Access Compliance Report

Public Rights-of-Way

(Curb Ramps)

Intersection ID: 13553	Main Street: WINGATE_AV	Cross Street: DODGE_AV	Location: SW
ADA ID: AEA93E346BD5	Ramp Type: PerpDiag	Initial Pass/Fail: Fail	Overall Compliance: No
Severity Score: 12.5			
Codes/Mitigation Info/Possible Solution		Field Measurements/Component Compliance

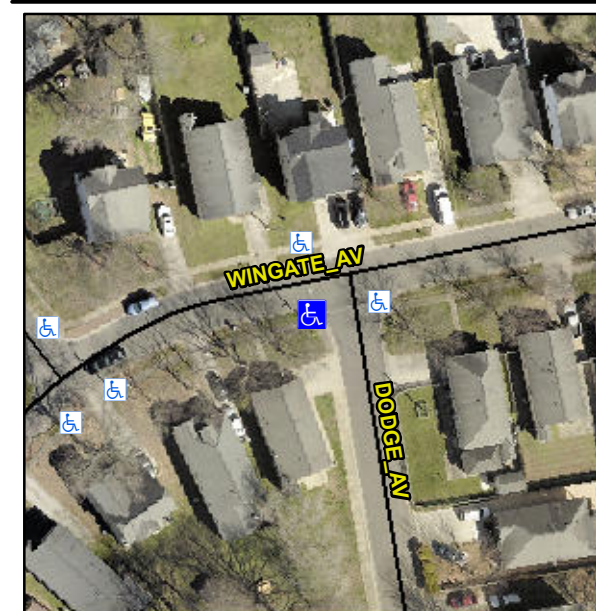
Remove & Replace Curb Ramp With Two New Directional Ramps or Equivalent.

Not Found, R304.2.2

Compliance	Description	Data	Compliance	Description	Data
N/A	Ramp Length (in)	72.0	No	Ramp Slope (%)	9.3
Yes	Ramp Width (in)	48.0	Yes	Ramp XSlope (%)	1.9
N/A	Flare Type LT	N/A	N/A	Flare Type RT	N/A
N/A	Flare Slope LT (%)	N/A	N/A	Flare Slope RT (%)	N/A
N/A	Flare Traversable LT?	N/A	N/A	Flare Traversable RT?	N/A
N/A	Landing Length (in)	N/A	N/A	DWS Provided?	N/A
N/A	Landing Width (in)	N/A	N/A	DWS Contrast?	N/A
N/A	Landing Slope (%)	N/A	N/A	DWS Length (in)	N/A
N/A	Landing X Slope (%)	N/A	N/A	DWS Full Width?	N/A
N/A	Landing Curb? (Y/N)	N/A	N/A	DWS Offset (in)	N/A
N/A	Shared Landing?	N/A			
N/A	Gutter Ponding?	N/A	N/A	Gutter Slope (%)	N/A
N/A	Gutter Lip Ht (in)	N/A	N/A	Gutter X Slope (%)	N/A
N/A	Painted X Walk1?	No	N/A	Painted X Walk2?	No
	X Walk 1 Direction	To E		X Walk 2 Direction	To N
N/A	X Walk 1 Width (in)	N/A	N/A	X Walk 2 Width (in)	N/A
	X Walk 1 Slope (%)	0.3		X Walk 2 Slope (%)	1.3
	X Walk 1 X Slope (%)	2.8		X Walk 2 X Slope (%)	1.6
